ENVIRONMENTAL REVIEW TEAM REPORT

THE MADISON RIDING CLUB PROPERTY

MADISON, CONNECTICUT

AUGUST, 1982

BEDROCK OUTCROP MAP

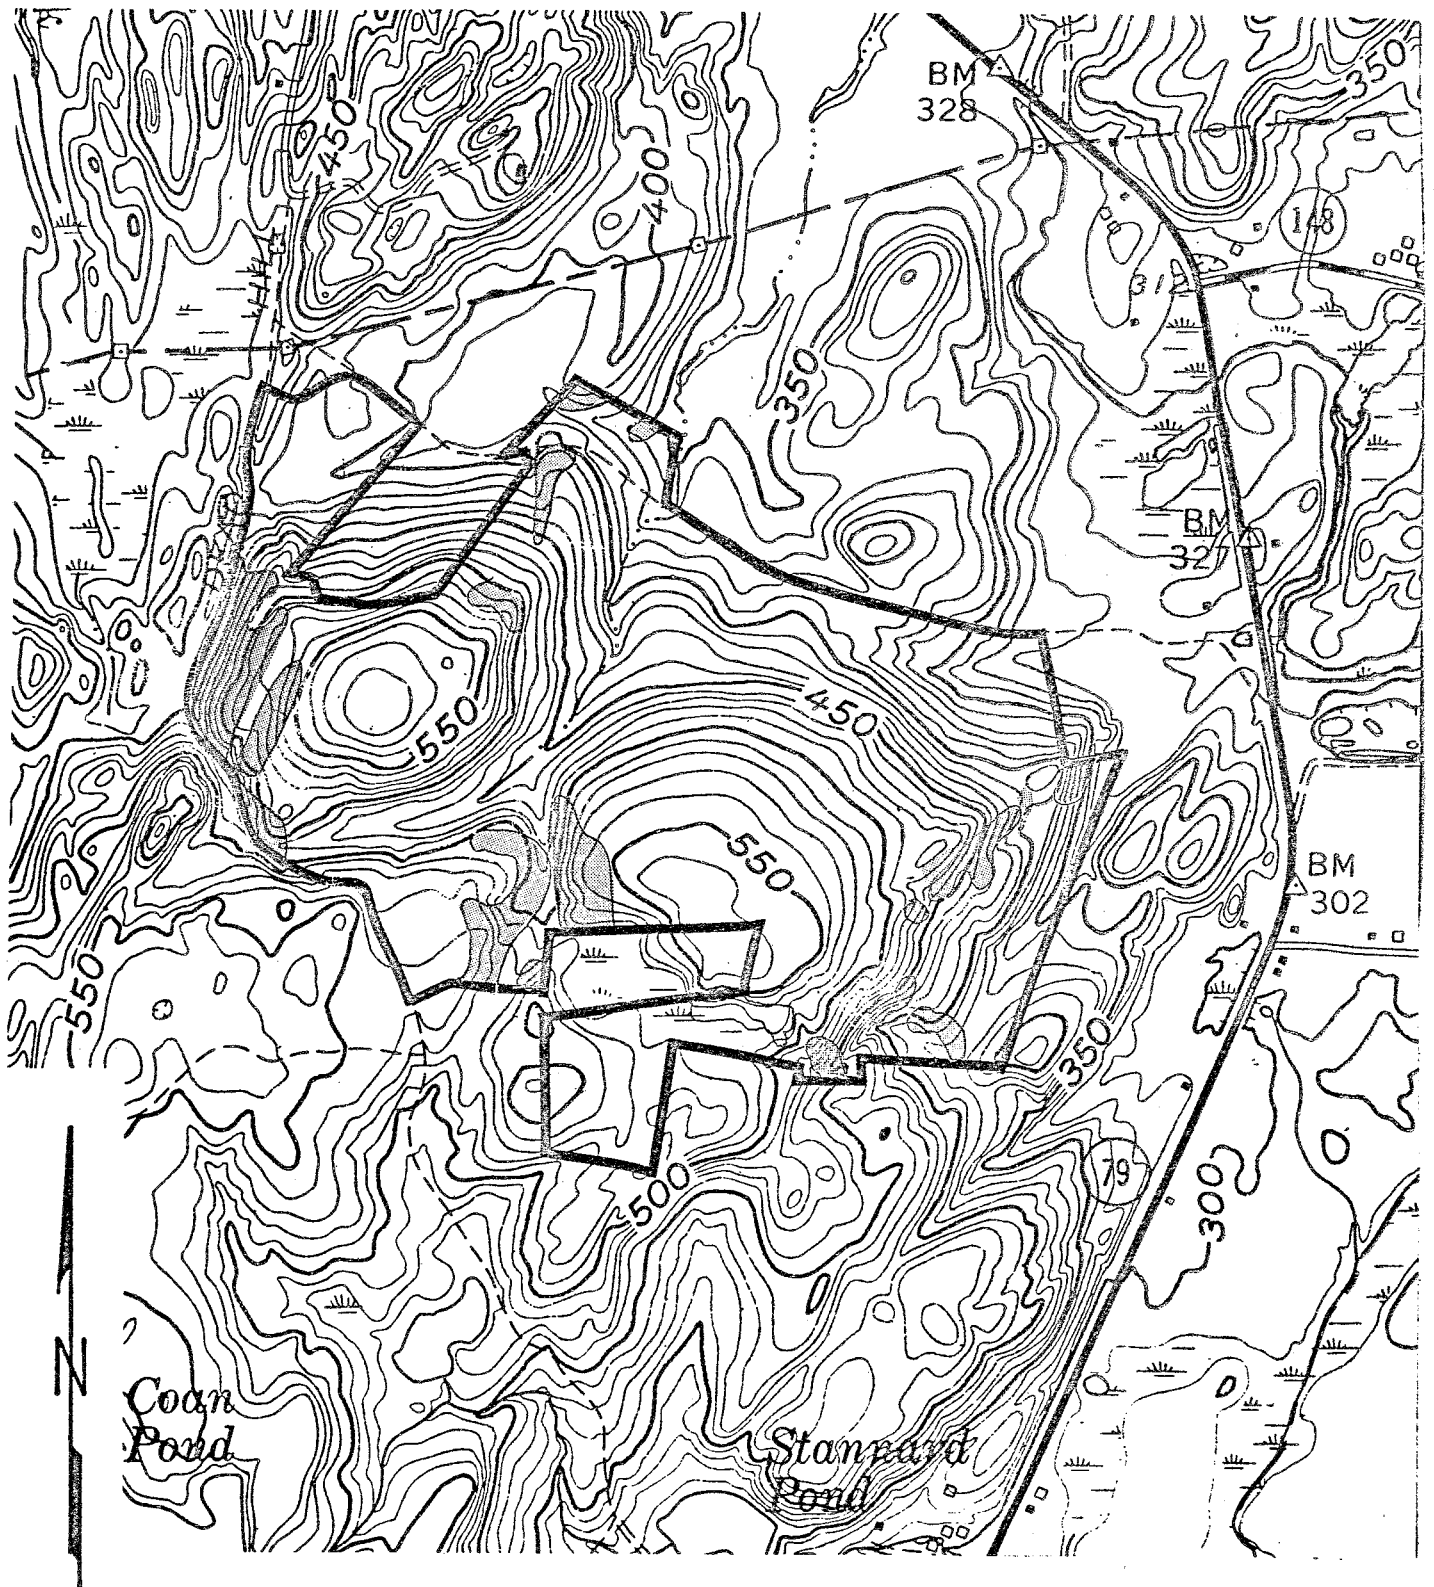
Bedrock was more prominently exposed in other areas of the site. Figure 2 shows the major outcrops either observed by the Team in the field or determined from aerial photographs. Soil maps for the site describe the soils in these areas as consisting almost entirely of Hollis-Rock Outcrop complex. (See Soils Map in Appendix.)

Pegmatite, a coarse-grained, quartz-and-feldspar-rich rock, constituted the majority of the outcrops seen on the property. Preliminary bedrock information for the State (Connecticut Geological and Natural History Survey Bulletin No. 84) suggests that a variety of rock types, including amphibolite gneiss, biotite gneiss and schist, feldspathic gneiss and granulite, quartzite, and garnet granulite, may in fact underlie the parcel. This is not inconsistent with the plethora of pegmatite outcrops; pegmatite may simply have intruded the "parent" rock types in a widespread series of dikes and sills. Being more resistant to weathering and erosion than many other local rock types, the pegmatite has remained as the most abundant outcrop material.

The occurrence of near-surface bedrock throughout the site will be a major hindrance to development. Engineered septic systems would be required in most areas, and blasting would probably be required in order to establish the internal road network. The differences among the various bedrock units on the site may influence the quality of groundwater to some extent: the more granular, quartz-rich and feldspar-rich rocks, such as pegmatite, may tend to produce less mineralized water than the mica-rich, structurally layered schists and gneisses. Not enough bedrock data is presently available to estimate the subsurface distribution of the various rock types.

SOILS MAP

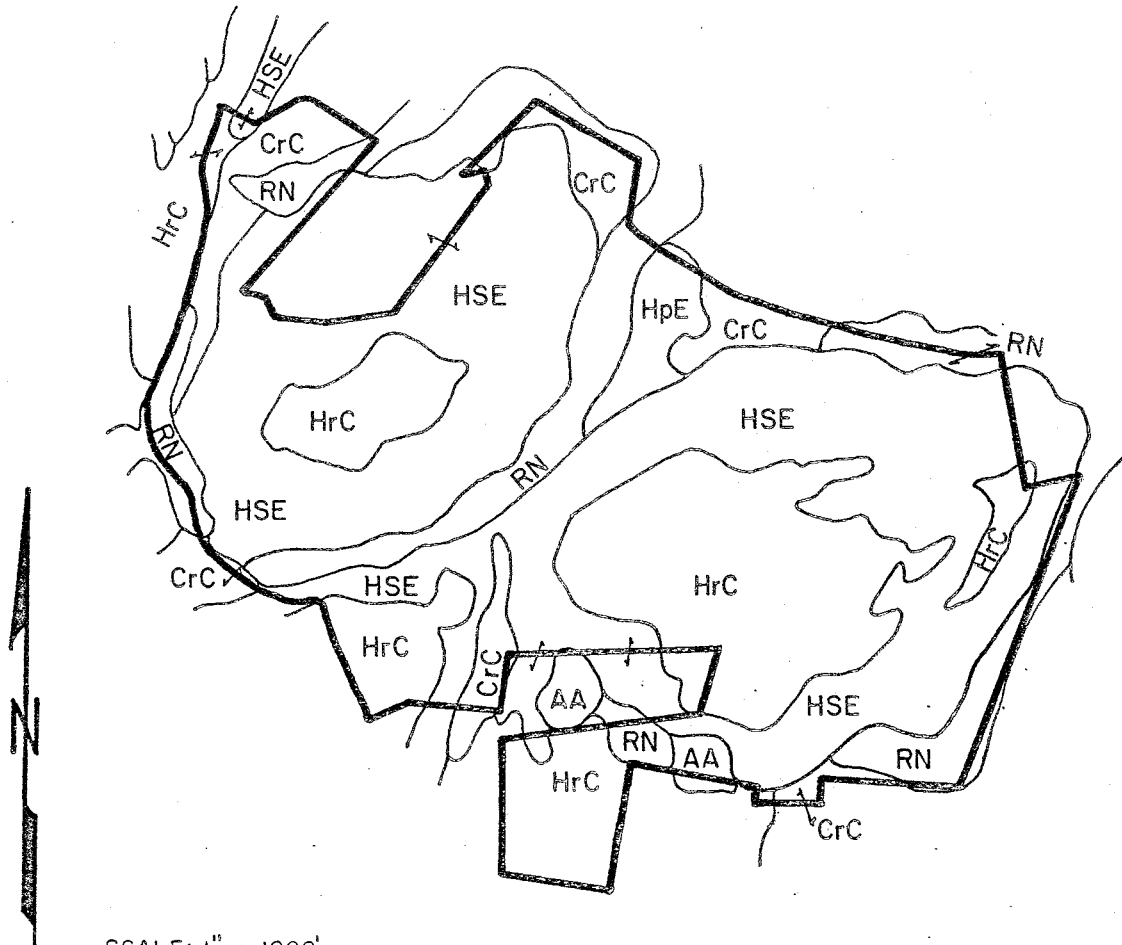
As noted previously, practically the entire Madison Riding Club Property is characterized by steep and shallow to bedrock soils or wetland soils. Field investigation of the site confirms the classification of the soils as mapped in the New Haven County Soil Report (see Appendix). There are, however, small inclusions of moderately deep to deep soils in between hills and along side slopes. These deeper soils are much more suitable for housing development. Due to the random and scattered distribution of these inclusions, however, backhoe excavations on each proposed lot may be necessary to find suitable areas for building and for septic systems.
